Item: 245kV CT

Customer: APTransco, Andhra Pradesh

List of Standard Drawings/Documents:

CHIEF ENGINEER/PROJECTS
APTRANSCO/VS/Vijayawada

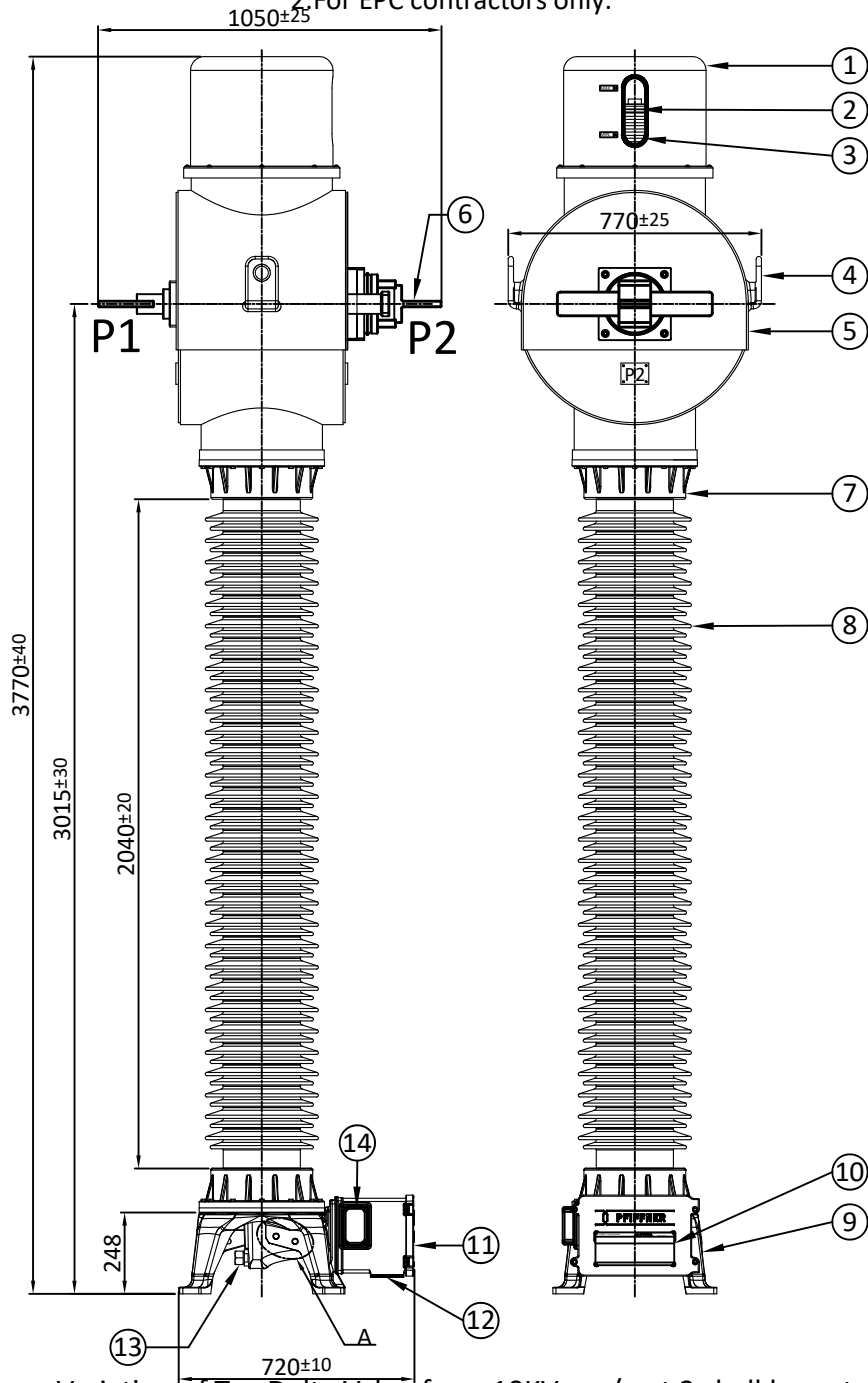
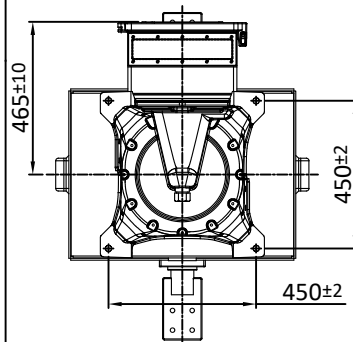
1. Minimum 300mm plinth shall be maintained for CT/PT/CVT/ Isolators/IVT in the substation during foundation works to ensure safe live to ground clearance as per IE rules.
2. Since the supply of terminal connectors is not in the scope of manufacturers as mentioned in the drawings. The EPC contractors shall be instructed to supply the same in line with CT/PT/CVT/Isolator /IVTs requirement and capatibility.

Variation of Tan Delta Value from 10KV um/sqrt 3 shall be not exceed 15%.

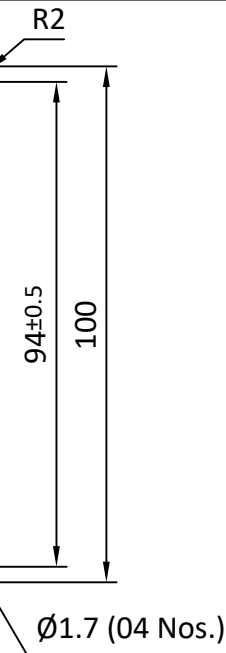
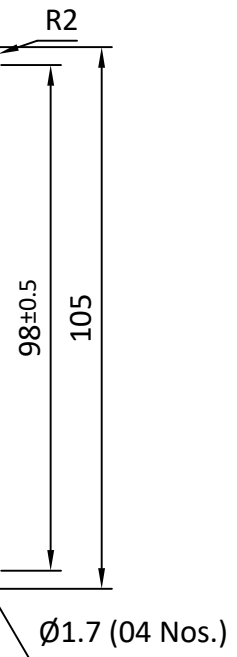
Variation of Tan Delta Value from 10KV um/sqrt 3 shall be not exceed 15%.

Drawing approval subject to valid vendor registration

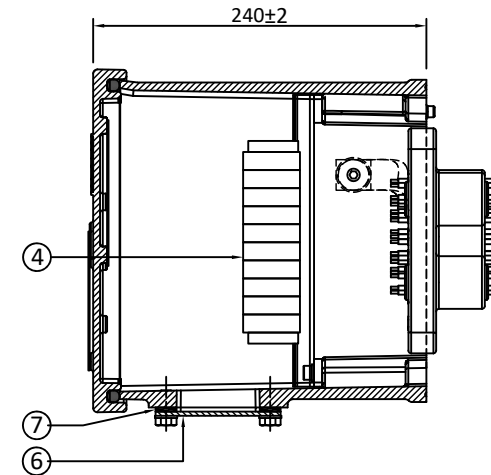
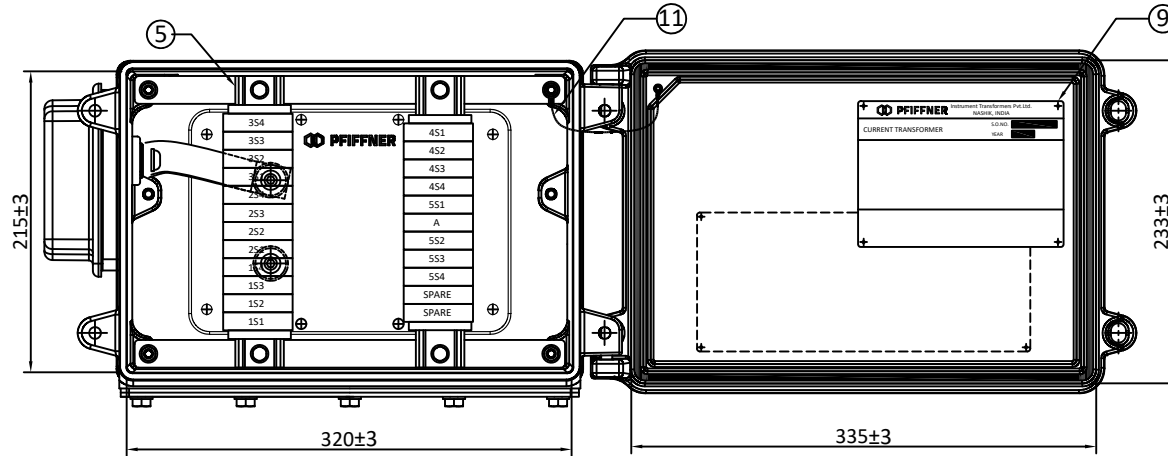
Variation of Tan Delta Value from 10KV um/sqrt 3 shall be not exceed 15%.

Drawing approval subject to valid vendor registration

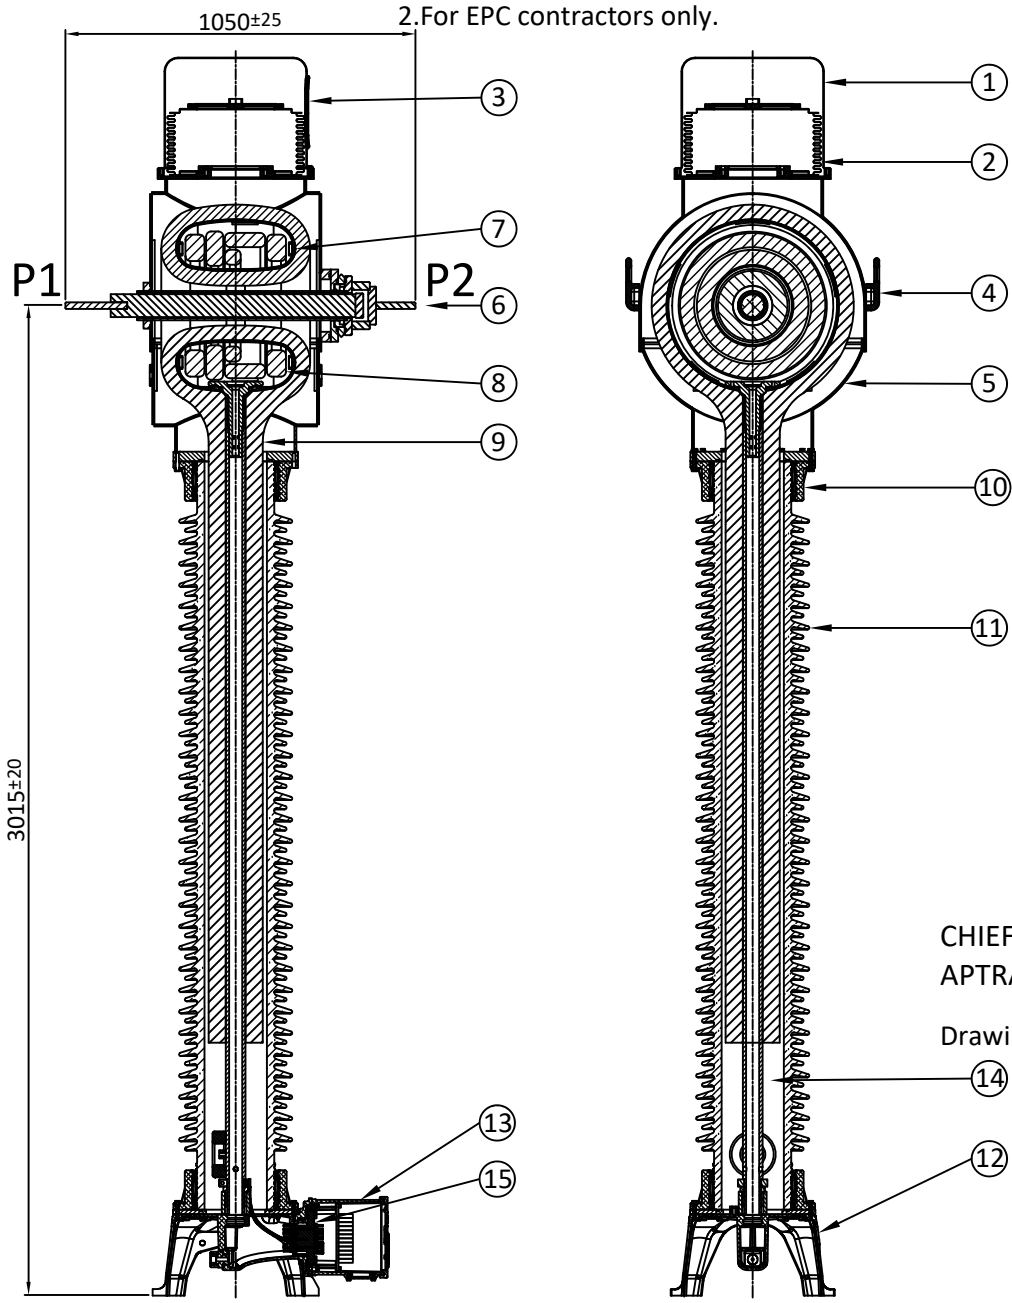
Drawing approval subject to valid vendor registration

Variation of Tan Delta Value from 10KV um/sqrt 3 shall be not exceed 15%.
